**COUNTY OF ALBEMARLE
STAFF REPORT SUMMARY**

Project Name: ZMA201200007 5 th Street Commercial	Staff: Elaine Echols
Planning Commission Public Hearing: March 15, 2016	Board of Supervisors Public Hearing: TBD
Owner: FTV Investments	Applicant: Katurah Roell
Acreage: 4.35 acres	Rezoning: Modify plan and proffers for property zoned HC Highway Commercial and LI Light Industrial
TMPS: 0.875 acre portion of 07600-00-00-055A0, 3.041 acre portion of 076M1-00-00-00100, and all of 07600-00-00-055C0	By-right use: Proffers restrict the use to hotels, motels, restaurants, service stations, convenience stores, and gift, craft, or antique shops according to the proffered plan; a proffered plan shows the limits of development, reflecting a special use permit for fill in the floodplain
Magisterial District: Scottsville	Proffers: Yes
Proposal: Request to amend proffers and application plan of ZMA199900013 for 4.35 acres on property zoned HC – Highway Commercial, which allows commercial and service; residential by special use permit (15 units/ acre) and property zoned LI Light Industrial, which allows – industrial, office, and limited commercial uses (no residential use). No zoning district change an

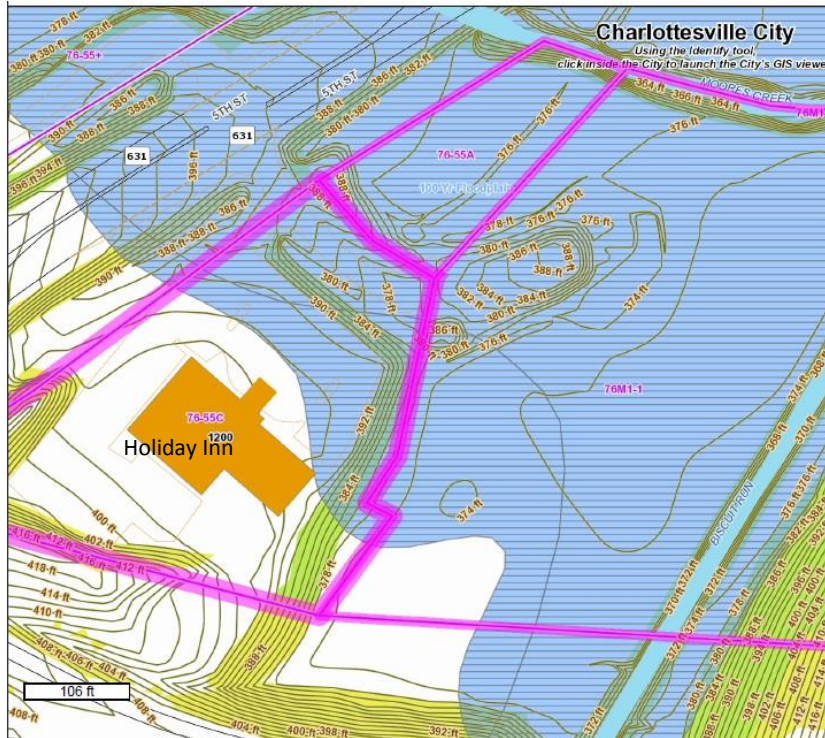
The County Engineer has provided the following comments, indicating that impacts on natural resources are not consistent with prior approvals:

1. *Please have the application show the current floodplain limits according to FEMA mapping. The proposed line or Conditional letter of Map Revision (CLOMR) lines do not appear to be the current regulatory limits.*

2. Please have the applicant clarify the limits of floodplain fill in the context of the previous approval. It appears that the proposed retaining wall may encroach further than the slope shown on previous concept plans. This would increase the proposed fill.
3. Please correct the buffer designation on the plan, and clarify the encroachment into the stream buffers. There is no 50' buffer in the WPO. There is only a 100' buffer. Up to 50' of encroachment and disturbance is permitted with mitigation. This should be compared to what was previously approved.

The image on the left shows both the floodplain and preserved slopes. Preserved slopes have been proposed for disturbance at the entrance and behind the Holiday Inn. Disturbances in both of these areas were approved in prior ZMA and SP approvals according to the plans.
